PUBLIC UTILITIES COMMISSION

EA2026-1426

SUBJECT: Electric Distribution Audit of PG&E's Fresno Division

**CPUC AUDIT FINDINGS
PG&E FRESNO DISTRIBUTION DIVISION
JANUARY 12-16, 2026**

Figure 1: Guy slack limit, TD-2305M-JA02

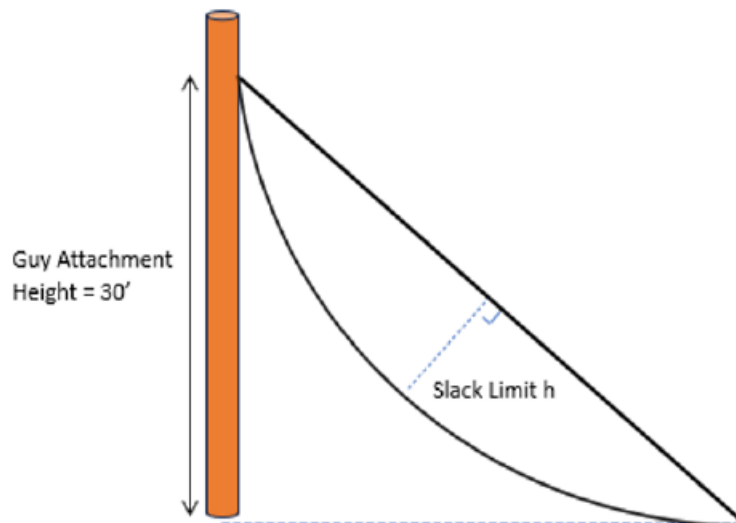
PG&E’s Utility Bulletin: TD-2305M-JA02-B005, Effective Date: 2/14/2025, Rev. 0, Section 3, Guy Loose Adjust states in part:

“The original assessment to determine the acceptable slack on the guy was only looking at a leaning pole scenario, in this scenario the stresses (e.g., bending of pole due to overload) was not considered. ATS has updated the assessment to consider the overload scenario, the bending scenario gives us the limiting slack value, which is at 1.5-foot of slack (worst-case) in all the pole class/lengths evaluated.”

See Figure 1 below from PG&E’s TD-2305M-JA02.

Per GO 95, Rule 56.2, guys are required to be maintained taut. PG&E’s Utility Bulletin: TD-2305M-JA02-B005 allows a deviation from taut by a maximum of one and a half (1.5) feet without regard to length or angle of attachment.

ESRB asserts that PG&E’s Utility Bulletin: TD-2305M-JA02-B005 must be revised to

comply with GO 95, Rule 56.2 which requires guys to be maintained taut in all circumstances.
